# UNITED STATES PATENT AND TRADEMARK OFFICE

APPLICATION NO.	FILING DATE	FIRST NAMED INVENTOR	ATTORNEY DOCKET NO.	CONFIRMATION NO.
10/577,463	09/28/2006	Jyrki Kauppinen	1028443-000073	5051
21839 7590 01/31/2008 BUCHANAN, INGERSOLL & ROONEY PC POST OFFICE BOX 1404 ALEXANDRIA, VA 22313-1404				
EXAMINER SKOVHOLT, JONATHAN				
ART UNIT 2877		PAPER NUMBER		
NOTIFICATION DATE 01/31/2008		DELIVERY MODE ELECTRONIC

# Office Action Summary

## **DETAILED ACTION**

Fig. 1 from Tank et al. (US Patent 5,148,235).

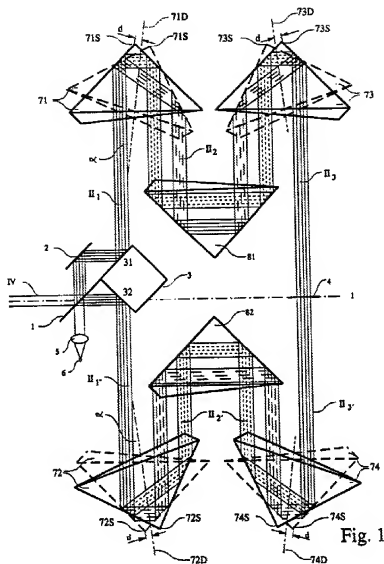
Regarding **claim 1**, Tank teaches an interferometer, comprising:

- a beamsplitter ((1) Fig. 1);
- at least one end reflector for returning beams (stationary retroreflectors (81) & (82) are the end reflectors); and

- a set of reflectors for reflecting the beams between the beamsplitter and the at least one end reflector (rotating retroreflectors ((71), (72), (73), and (74)),
- at least some of said set of reflectors being adapted to be rotatable around an axis (the rotating retroreflectors are adapted to be rotatable around an axis),
- said set of reflectors comprises two angle reflectors, constituted by plane reflectors (the rotating retroreflectors are angled and comprised of two plane reflectors), and wherein said at least one end reflector comprises an angle reflector constituted by plane reflectors (the stationary retroreflectors are angled and comprised of two plane reflectors), and that an angle line of the at least one end reflector is arranged perpendicular to an angle line of the two angle reflectors of the set of reflectors (see Fig. 1).

Regarding **claim 2**, Tank teaches all as applied to claim 1 above, in addition Tank teaches an interferometer wherein the angle reflector of the at least one end reflector is constituted by two plane reflectors, between which is provided an angle typically of about 72-107 degrees (the

angle between the two plane reflectors of the end reflectors (81) & (82) is within this range as is shown in Fig. 1).

Regarding **claim 4**, Tank teaches all as applied to claim 1 above, in addition Tank teaches an interferometer wherein, said set of reflectors further comprises at least one pair of plane reflectors (the set of reflectors (71), (72), (73), and (74) are each comprised of a pair of plane reflectors).

Regarding **claim 5**, Tank teaches all as applied to claim 4 above, in addition Tank teaches an interferometer wherein the pair of plane reflectors has its plane reflectors arranged in such a way that the beams, coming from the beamsplitter (2) to the pair of plane reflectors (the two sides of the retroreflectors (71), (73), or (74)), travel by way of at least one of the set of reflectors (retroreflectors (71), (73), or (74)) and hit the at least one end reflector (82) perpendicularly to the angle line of the at least one end reflector, the beams reflected from the at least one end reflector returning over the same direction but laterally shifted back to the beamsplitter (the outgoing beam that is reflected by retroreflector (82) will be parallel to the incoming beam and therefore the beam will return in the same direction however the incoming and outgoing beams are laterally shifted from one another) (see Fig. 1).

Regarding **claim 6**, Tank teaches all as applied to claim 1 above, in addition Tank teaches an interferometer wherein the interferometer is arranged in such a way that a beam to be delivered to the interferometer is conductible to the beamsplitter (2), the beamsplitter being arranged to divide the beam into two beams, namely a first beam and a second beam, the first beam is arranged to be reflected from the beamsplitter to a first angle reflector (retroreflector (71)) and further towards the at least one end reflector (retroreflector (81)), and to return from

the at least one end reflector over the same direction but laterally shifted back to the beamsplitter (the outgoing beam that is reflected by retroreflector (81)) will be parallel to the incoming beam and therefore the beam will return in the same direction however the incoming and outgoing beams are laterally shifted from one another), the second beam is arranged to pass through the beamsplitter and to advance to a second angle reflector (retroreflector (72)) and further towards the at least one end reflector (retroreflector (82)), and to return over the same direction but laterally shifted back to the beamsplitter (the outgoing beam that is reflected by retroreflector (82)) will be parallel to the incoming beam and therefore the beam will return in the same direction however the incoming and outgoing beams are laterally shifted from one another), and that the beamsplitter is arranged to combine the first and second beams returning from the at least one end reflector for a single beam (the beamsplitter combines the beams after being reflected by the retroreflectors) (see Fig. 1).

Regarding **claim 7**, Tank teaches all as applied to claim 4 above, in addition Tank teaches an interferometer wherein the interferometer is arranged in such a way that a beam to be delivered to the interferometer is conductible to the beamsplitter (2), the beamsplitter being arranged to divide the beam into two beams, namely a first beam and a second beam, the first beam is arranged to be reflected from the beamsplitter to a first plane reflector (one of the reflective sides of retroreflector (71)), from the first plane reflector to the first angle reflector (retroreflector (71)), from a first angle reflector towards the at least one end reflector (retroreflector (81)), and to return from the at least one end reflector over same direction but laterally shifted (the outgoing beam that is reflected by retroreflector (81)) will be parallel to the incoming beam and therefore the beam will return in the same direction however the incoming

and outgoing beams are laterally shifted from one another) back to the beamsplitter, the second beam is arranged to pass through the beamsplitter and to advance to a second plane reflector (one of the reflective sides of retroreflector (72)) and to reflect from the second plane reflector to a second angle reflector (retroreflector (72)), from the second angle reflector towards the at least one end reflector (retroreflector (82)), and to return from the at least one end reflector over the same direction but laterally shifted back to the beamsplitter (retroreflector (82)), and to return over the same direction but laterally shifted back to the beamsplitter (the outgoing beam that is reflected by retroreflector (82) will be parallel to the incoming beam and therefore the beam will return in the same direction however the incoming and outgoing beams are laterally shifted from one another), the beamsplitter is arranged to combine the first and the second beams returning from the at least one end reflector for a single beam (the beamsplitter combines the beams after being reflected by the retroreflectors) (see Fig. 1).

Regarding **claim 10**, Tank teaches a method in an interferometer, wherein optical beams are guided using at least two angle reflectors (rotating retroreflectors ((71), (72), (73), and (74)), constituted by plane reflectors (the retroreflectors are made of two plane reflectors), and at least one end reflector constituted by plane reflectors (stationary retroreflectors (81) & (82) are the end reflectors, which are made of two plane reflectors), and wherein an angle line of the at least one end reflector is arranged perpendicular to an angle line the two reflectors of the set of reflectors (see Fig. 1).

Regarding **claim 11**, Tank teaches an analyzer, comprising an interferometer, comprising;

- at least a beamsplitter ((1) Fig. 1);
- at least one end reflector for returning beams (stationary retroreflectors (81) & (82) are the end reflectors); and

- a set of reflectors for reflecting the beams between the beamsplitter and the at least one end reflector (rotating retroreflectors ((71), (72), (73), and (74)), at least some of said set of reflectors being adapted to be rotatable around an axis (the rotating retroreflectors are adapted to be rotatable around an axis), said set of reflectors comprises two angle reflectors retroreflectors, constituted by plane reflectors ((71), (72), (73), and (74) are angle reflectors that have two plane reflectors associated with each retroreflector), and said at least one end reflector is an angle reflector constituted by plane reflectors (the stationary retroreflectors are angled and comprised of two plane reflectors), and an angle line of the at least

one end reflector is arranged perpendicular to an angle line of both of the angle reflectors (see Fig. 1).
